NUMBER
JTB00070
Version 1

TECHNICAL BULLETIN

Transmission Noise During Gear Shifts – Repair Procedure

SQUAWK/CHIRP NOISE DURING TRANSMISSION GEAR SHIFTS

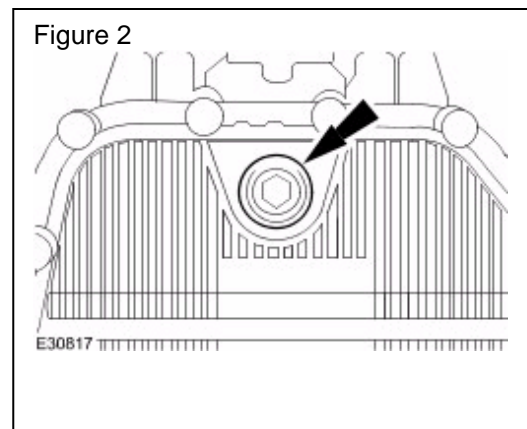
1. Raise vehicle on a four-post ramp.
2. If an S-TYPE vehicle is being repaired, remove the engine undertray. (Figure 1)
3. Place clean drain container under the transmission.

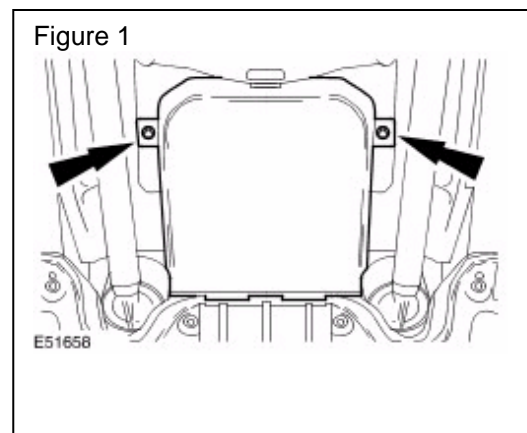
4. Undo and partially remove the transmission fluid drain plug. (Figure 2)
5. Collect one liter (33.8 oz) of fluid from the transmission into a clean measuring jug.
6. Reinstall and tighten the transmission fluid drain plug to 8Nm (5.9 lbf ft).
